Office Action Summary

10/646,478

KAWAGOE, DAISUKE

DETAILED ACTION

FIG. 6

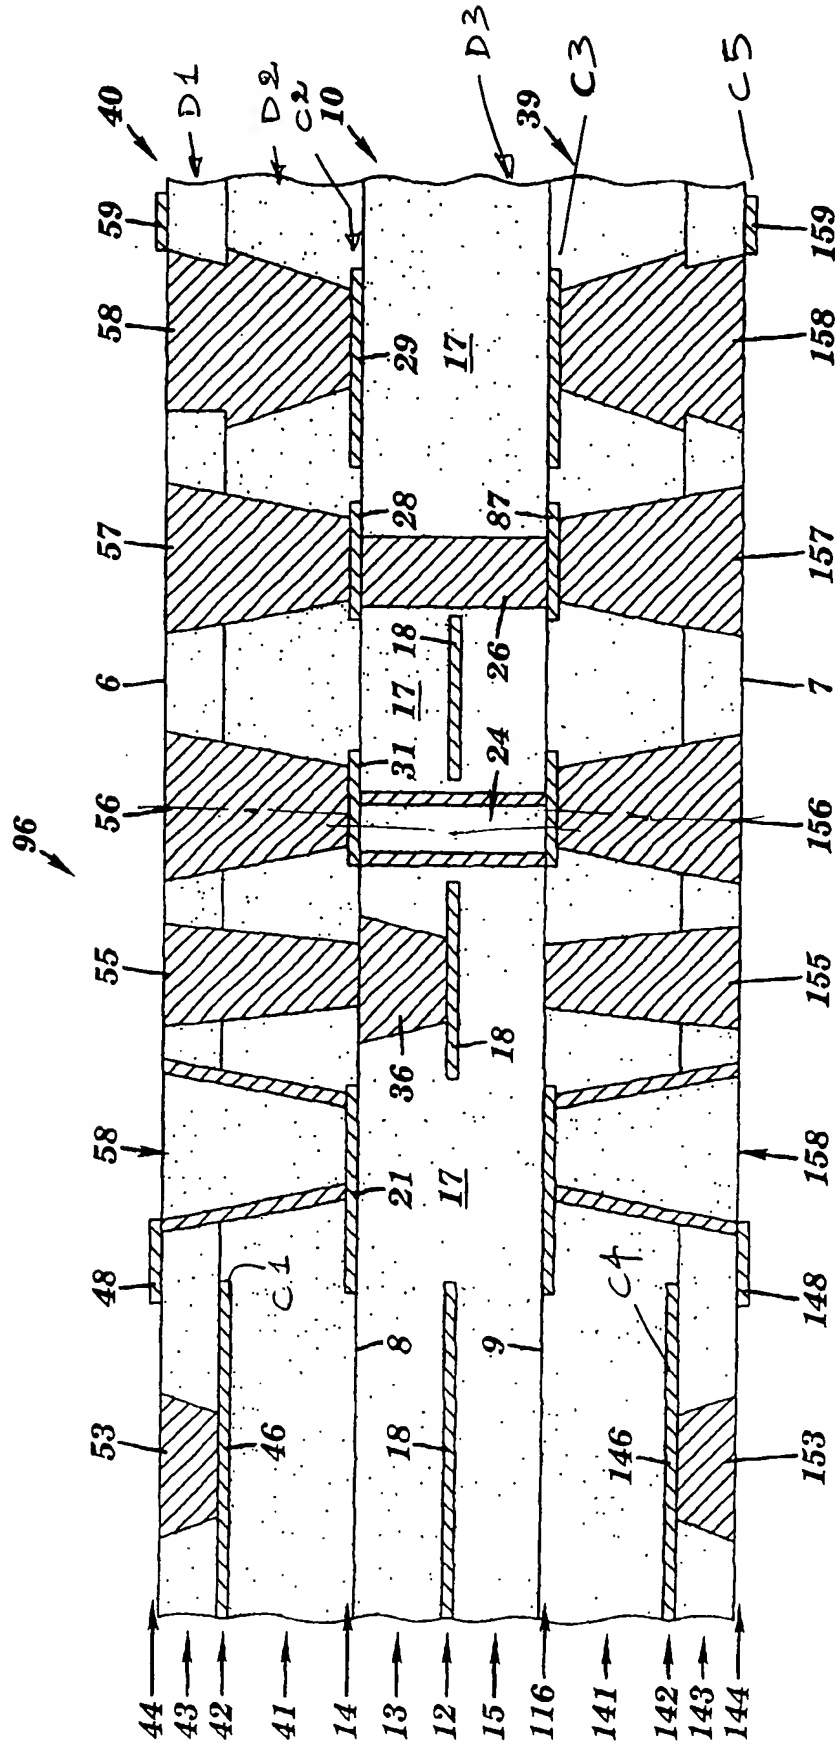
Regarding claim 40, Carpenter, in figure 6, discloses a substrate comprising: a first dielectric layer (D1, as marked up on figure 6 in appendix "A"); a second dielectric layer (D2, as marked up on figure 6 in appendix "A"); a first conductive layer (C1, as marked up on figure 6 in appendix "A"); between the first and second dielectric layers; a third dielectric layer (D3, as marked up on figure 6 in appendix "A"); the second dielectric layer being between the first and third dielectric layers; a second conductive layer (C2, as marked up on figure 6 in appendix "A"); between the second dielectric layer and the third dielectric layer, the second conductive layer including a first skip via (57) that extends through the first and second dielectric layers; and a third conductive layer (C3) on the third dielectric layer, the third conductive layer including a second via (26) that extends through the third dielectric layer, the second via and the first skip via being stacked on top of one another (see marked up figure 6 in appendix "A").

Regarding claim 41, Carpenter further discloses the first skip via includes a longitudinal axis (longitudinal axis passing through the first skip via, see marked up in figure 6, in appendix "A") and the second via includes a longitudinal axis (longitudinal axis passing through the second via, see marked up in figure 6, in appendix "A"), the

longitudinal axis of the first skip via being substantially aligned with the longitudinal axis of the second via (see marked up in figure 6, in appendix "A").

Regarding claim 42, Carpenter further discloses the first, second and third dielectric layers are formed on a core (C5, see marked up in figure 6, in appendix "A").

Regarding claim 43, Carpenter further discloses a fourth conductive layer (C4, see marked up in figure 6, in appendix "A") between the first dielectric layer and the core.

FIG. 7

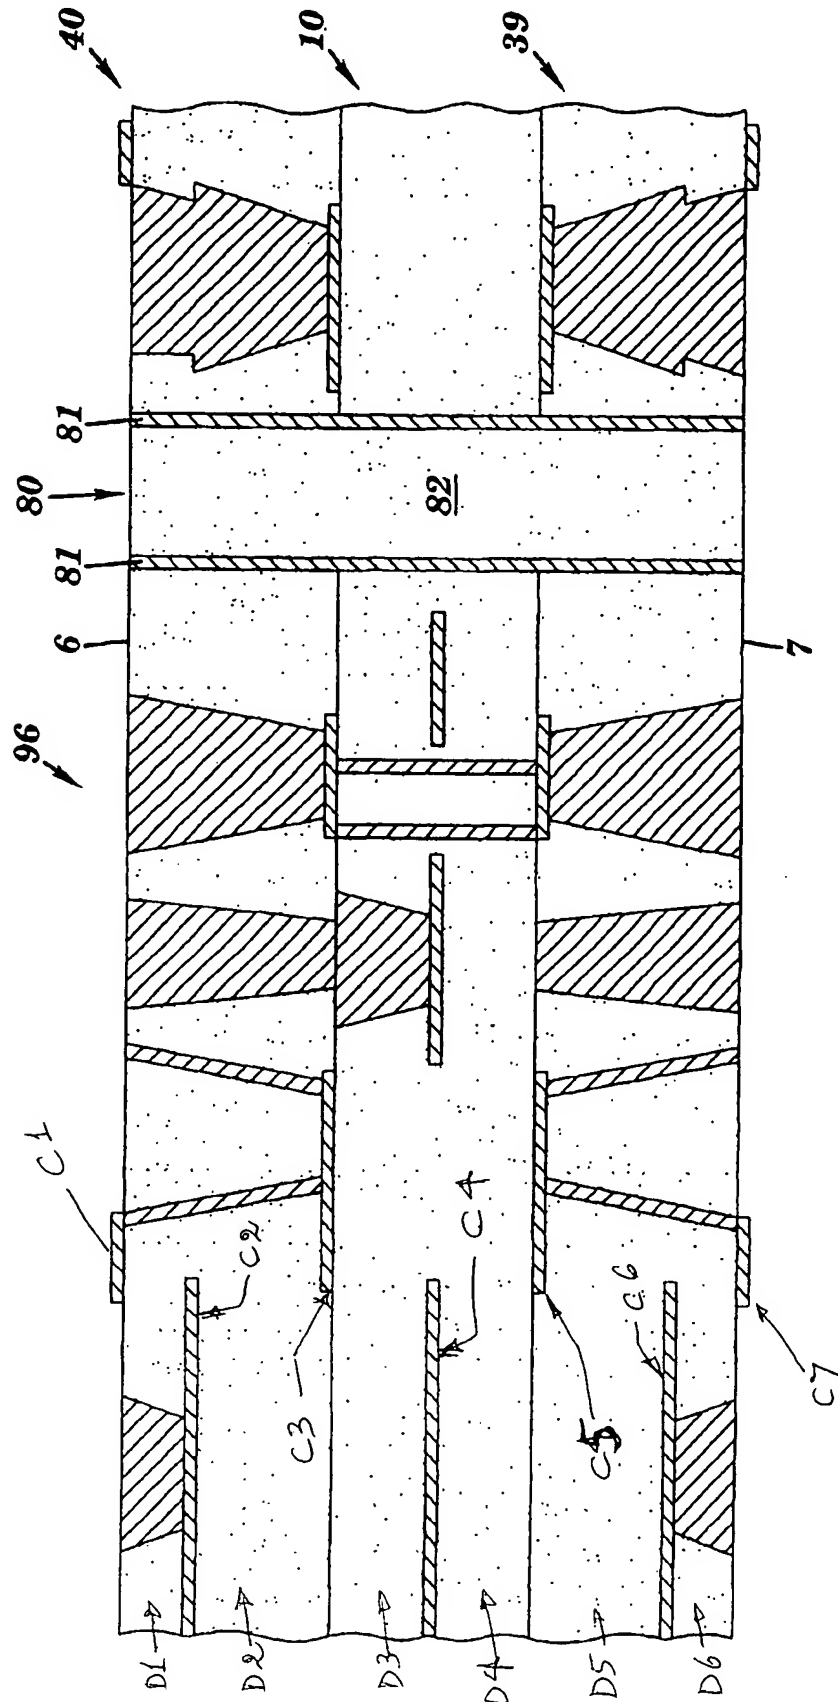
Regarding claim 47, Carpenter, in figure 7, discloses a substrate comprising: a first dielectric layer (D1, marked up on figure 7 in appendix "B"); a second dielectric layer (D2, marked up on figure 7 in appendix "B"); a first conductive layer (C2, marked up on figure 7 in appendix "B") between the first and second dielectric layers; a third dielectric layer (D3, marked up on figure 7 in appendix "B"), the second dielectric layer being between the first and third dielectric layers; a second conductive layer (C3, marked up on figure 7 in appendix "B") between the second and third dielectric layers,

the second conductive layer including a first skip via (V1, marked up on figure 7 in appendix "B") that extends through the first and second dielectric layers; a fourth dielectric layer (D4, marked up on figure 7 in appendix "B"), the third dielectric layer being between the second and fourth dielectric layers; a third conductive layer (C4, marked up on figure 7 in appendix "B") between the third and fourth dielectric layers; and a fourth conductive layer (C5, marked up on figure 7 in appendix "B") on the fourth dielectric layer, the fourth conductive layer including a second skip via (V2, marked up on figure 7 in appendix "B") that extends through the third and fourth dielectric layers, the second skip via and the first skip via being stacked on top of one another (see marked figure 7 in appendix "B").

Regarding claim 48, Carpenter further discloses the first skip via and the second skip via each include a longitudinal axis (longitudinal axis of axis of first skip via and second skip via), the longitudinal axis of the first skip via being substantially aligned with the longitudinal axis of the second skip via (see marked up figure 7 in appendix "B").

Regarding claim 49, Carpenter further discloses the first, second, third and fourth dielectric layers are formed on a core (C7, as marked up on figure 7 in appendix "B").

Regarding claim 50, Carpenter further discloses a fifth conductive layer (C6, marked up on figure 7 in appendix "B") between the first dielectric layer and the core.

Regarding claim 54, Carpenter discloses all the features of the claimed invention as applied to claim 47 above, including a fifth dielectric layer (D5, marked up on figure 7 in appendix "B"), the fourth conductive layer (C5, marked on figure 7 in appendix "B") being between the fourth and fifth dielectric layers; a sixth dielectric layer (D6, marked up on figure 7 in appendix "B"), the fifth dielectric layer being between the fourth and sixth dielectric layers; a fifth conductive layer (C6, marked up on figure 7 in appendix "B") between the fifth and sixth dielectric layers; a sixth conductive layer (C7, marked up on figure 7 in appendix "B") on the sixth dielectric layer. Carpenter further discloses a third sip via (V3, marked up on figure 7 in appendix "B"), a third skip via that

extends through the fifth and sixth dielectric layers, but does not disclose the sixth conductive layer including connected to the third skip via. However, as can be seen at various places in the figure, the conductor layer / patterns are connected to the via depending upon the desired electrical connection for signal, power or ground connections.

Regarding claim 55, Carpenter further discloses the first, second and third skip vias each include a longitudinal axis, the longitudinal axis of the first skip via being substantially aligned with the longitudinal axis of the second and third skip vias (see marked up figure 7 in appendix "B").

Regarding claim 56, Carpenter further discloses the first, second, third, fourth, fifth and sixth conductive layers are patterned conductive layers (see figure marked up figure 7 in appendix "B").

Fig. 6

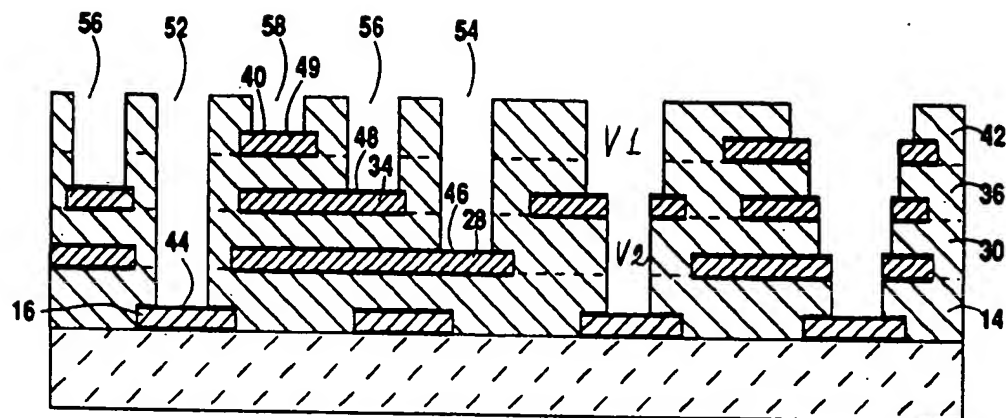
Regarding claim 40, Kumar, in figure 6, discloses a substrate comprising: a first dielectric layer (41); a second dielectric layer (36); a first conductive layer (42); between the first and second dielectric layers; a third dielectric layer (14); the second dielectric layer being between the first and third dielectric layers; a second conductive layer (34) between the second dielectric layer and the third dielectric layer, the second conductive layer including a first skip via (V1, as marked on figure 6 in appendix "C") that extends

through the first and second dielectric layers; and a third conductive layer (16) on the third dielectric layer, the third conductive layer including a second via (V2, as marked on figure 6 in appendix "C") that extends through the third dielectric layer, the second via and the first skip via being stacked on top of one another (see marked up figure 6).

Regarding claim 41, Kumar further discloses the first skip via includes a longitudinal axis (longitudinal axis passing through the first skip via, V1, see marked up in figure 6, in appendix "C") and the second via includes a longitudinal axis (longitudinal axis passing through the second via, V2, see marked up in figure 6, in appendix "C"), the longitudinal axis of the first skip via being substantially aligned with the longitudinal axis of the second via (see marked up figure 6, in appendix "C").

Fig. 6F

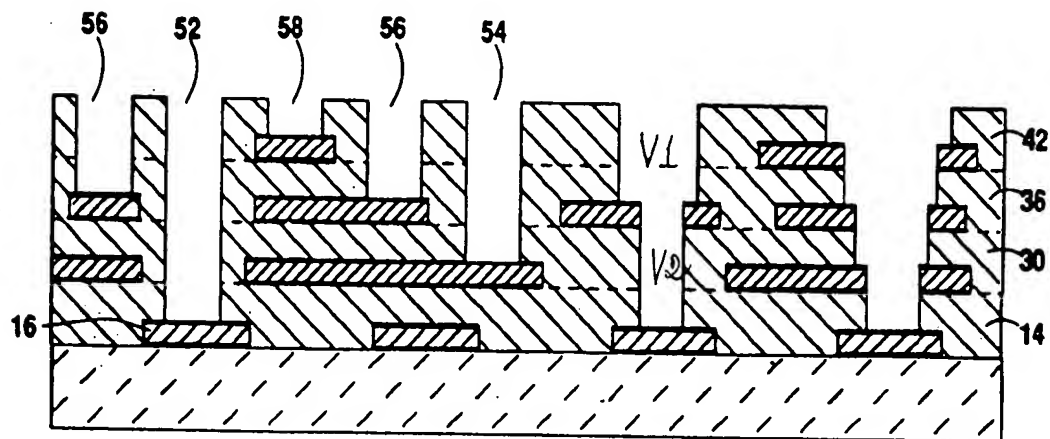
Regarding claim 47, Kumar, in figure 6F, discloses a substrate comprising: a first dielectric layer (42); a second dielectric layer (36); a first conductive layer

(conductive layer between the dielectric layer 42 and 36) between the first and second dielectric layers; a third dielectric layer (30), the second dielectric layer being between the first and third dielectric layers; a second conductive layer (conductive layer between the dielectric layer 36 and 30) between the second and third dielectric layers, the second conductive layer including a first skip via (V1, as marked on figure 6F in appendix "D") that extends through the first and second dielectric layers; a fourth dielectric layer (14), the third dielectric layer being between the second and fourth dielectric layers; a third conductive layer (conductive layer between the dielectric layers 30 and 40) between the third and fourth dielectric layers; and a fourth conductive layer (conductive layer on dielectric layer 14) on the fourth dielectric layer, the fourth conductive layer including a second skip via (V2, as marked on figure 6F in appendix "D") that extends through the third and fourth dielectric layers, the second skip via and the first skip via being stacked on top of one another (see marked up figure 6F).

Regarding claim 48, Kumar further discloses the first skip via and the second skip via each include a longitudinal axis (longitudinal axis of axis of first skip via V1 and second skip via V2), the longitudinal axis of the first skip via being substantially aligned with the longitudinal axis of the second skip via (see marked up figure 6F in appendix "D").
